RC200343: Land Use Consent

General

Site Plan

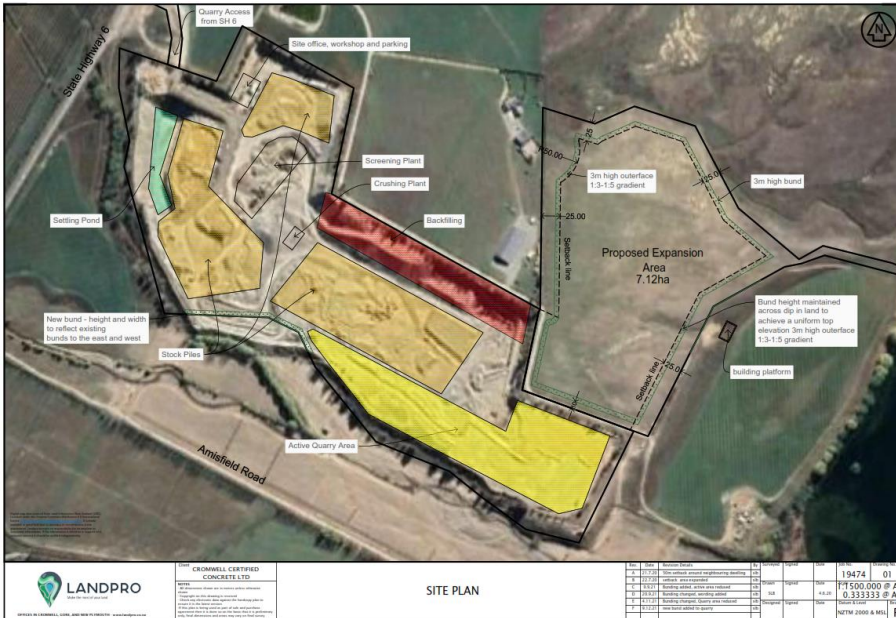
Commented [MC4]: The Site Plan and Mine Plan (Maps 1-4) are the key plans to be referenced.

12. Within 12 months of the exercise of this consent, the consent holder shall construct a new section of bund within Lot 8 DP 301379 along its boundary with Lot 2 DP 508108 (shown in 'Site Plan Rev F' attached as Appendix 1 to this consent). Following construction, the new section of bund shall be immediately stabilised using mulch or another suitable product. As soon as practicable following construction, it shall be planted with native plant species and

13. The height of the new section of bund to be formed within Lot 8 DP 301379 along its boundary with Lot 2 DP 508108 shown in 'Site Plan Rev F' attached as Appendix 1 to this consent shall be the same height (within 200 mm) of the existing bund immediately to the west and east of the new section.
